Re: Hudson Logistics Center

Response to Public Comments -- Traffic
Hudson, New Hampshire
Langan Project No.: 151010101
October 14, 2020- Page 1 of 44

Re: Response to Public Comments -- Traffic
Hudson Logistics Center
Hudson, New Hampshire
Langan Project No.: 151010101

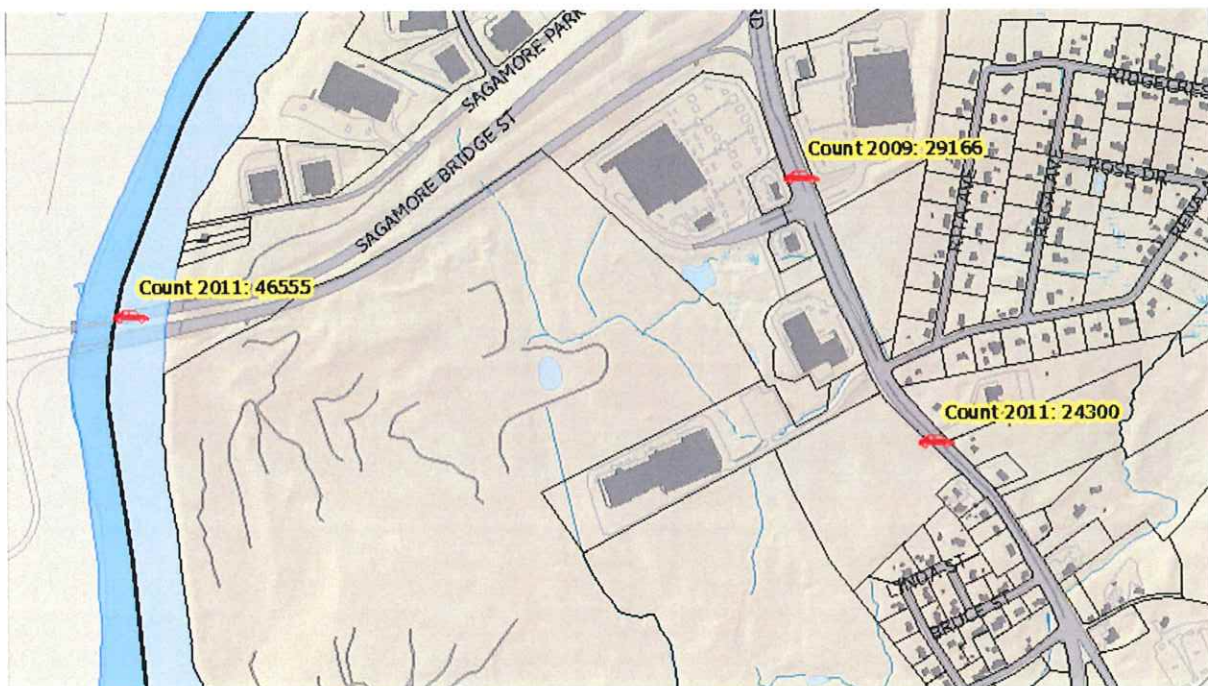
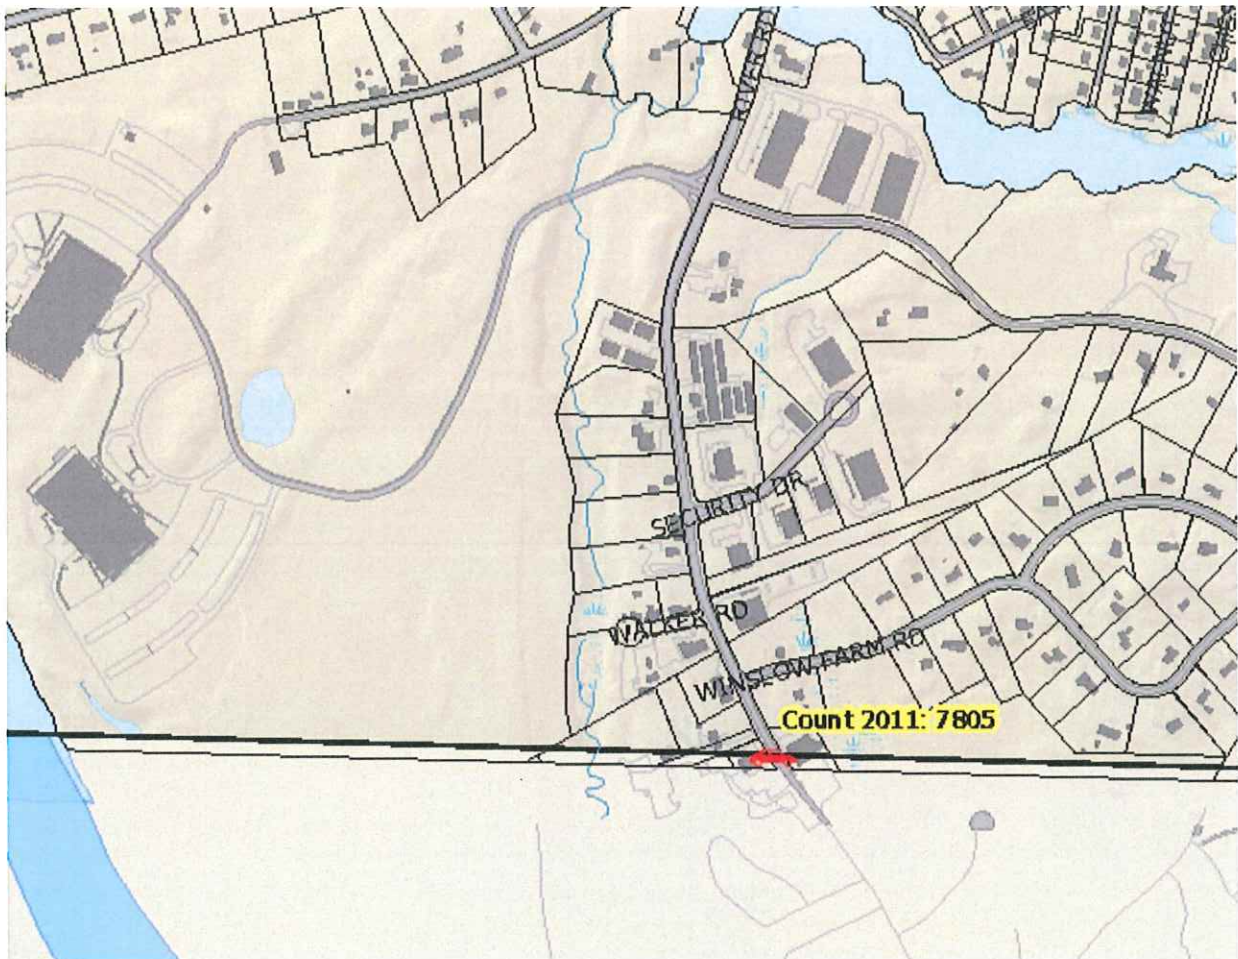
- In Appendix A, figure KO103 shows that north bound will have three left turning lanes onto Sagamore Bridge and will drop to two lanes slowly. I'm concerned that:
 - There will be traffic slow down due to lane merge during high traffic periods.
 - There will be more accidents at the Sagamore bridge road and Lowell Rd intersection due to lane changes at the three turning lanes and at the Walmart Boulevard and Lowell Rd intersection due to lane changes. I have seen many people change lanes at the last minute and almost cause an accident at these intersections when trying to turn left onto Sagamore Bridge. According to the studied data, most accidents among the studied happened at the intersection of Sagamore bridge and Lowell Rd and Walmart Boulevard and Lowell Rd already.

- I'm concerned for the traffic at the intersection of Lowell Rd and Walmart Boulevard. According to Table 7 (page 22 of 42), the delay time for NB-TT (north bound through traffic) will degrade from LOS C to LOS E without improvement and with improvement it will still be LOS D. The delay with improvement is twice as long as without build during peak hour and the traffic there is already bad. The traffic at the intersection of Lowell Rd and Reva Ave also degrade from LOS A to LOS B with the delay doubling what it is now (without the pandemic). I focused on these two intersections because they will directly affect me every day. The traffic study conclusion states that "the intersections analyzed will maintain acceptable or improve on the no-build traffic operating conditions." I disagree. We the residents will be the ones who drive through these intersections every day and experience the increased traffic every day. Our quality of life will suffer. Milford, MA regretted their decision to approve an Amazon distribution center due to traffic. I don't want us to make the same mistake. Sincerely, Mu-Jane Monk, 13 Fairway Dr

Response: The TIS details the anticipated trip generation for the redevelopment and the proposed improvements that will not only mitigate the additional traffic, it will significantly improve upon existing conditions. The trip generation and methodology has been reviewed and approved by NHDOT, is being peer-reviewed by VHB, and will be presented to the Planning Board for its review and consideration. The Milford facility cited in the comment is not the type of facility being proposed at the HLC, as will be explained at a future Planning board hearing.

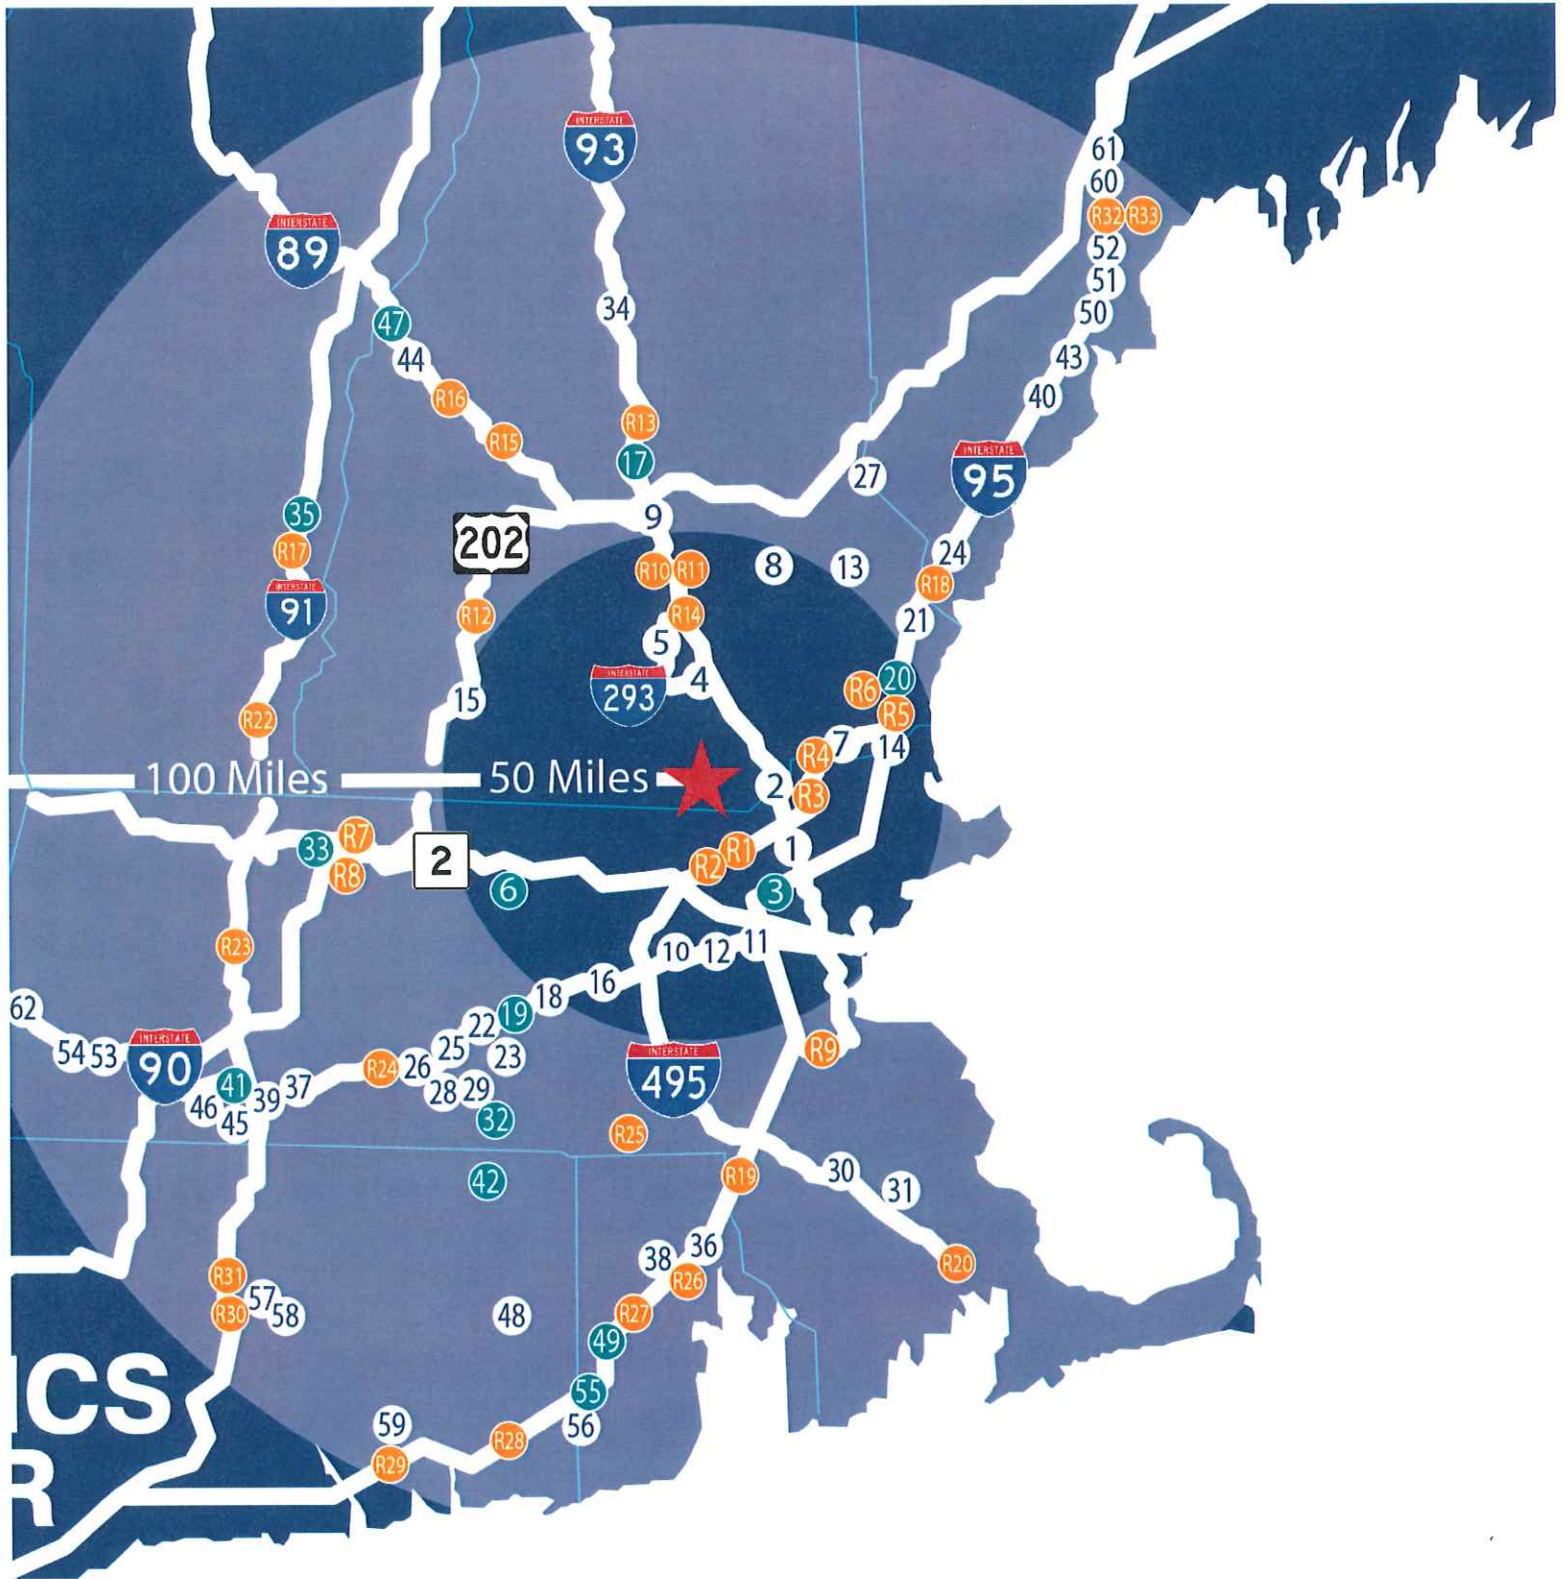
111. Tractor Trailer Fueling / Maintenance - Tractor trailer trucks always have maintenance issues (oil and gas leaks) which will end up getting into the soil causing pollution issues. How will this impact contamination especially since it is so close to the Merrimack River? Has there been a study on this?

Response: The proposed site has been designed with BMPs and treatment trains to address water quality. A detailed stormwater maintenance plan has been provided as part of the application and no impacts are anticipated for the Merrimack River, as confirmed by the Nashua Regional Planning Commission and the Lower Merrimack River Advisory Committee.
